ADDENDUM No. 7 REQUEST FOR TENDER ARIBA Doc3398579373 CLOSING DATE (REVISED): 12:00 NOON (LOCAL TIME), April 26, 2021

For: Toronto Accessibility Upgrades - Group 29 at Toronto, Ontario

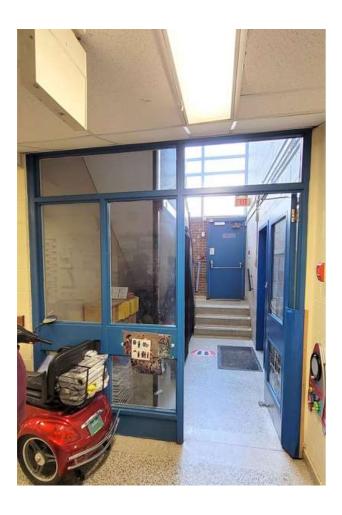
Q4: Elevation for door 102 is missed.

A4 - See below photo of existing assembly. New assembly to match. Refer to door schedule and to door types on G1004 (note that this is a rated assembly)
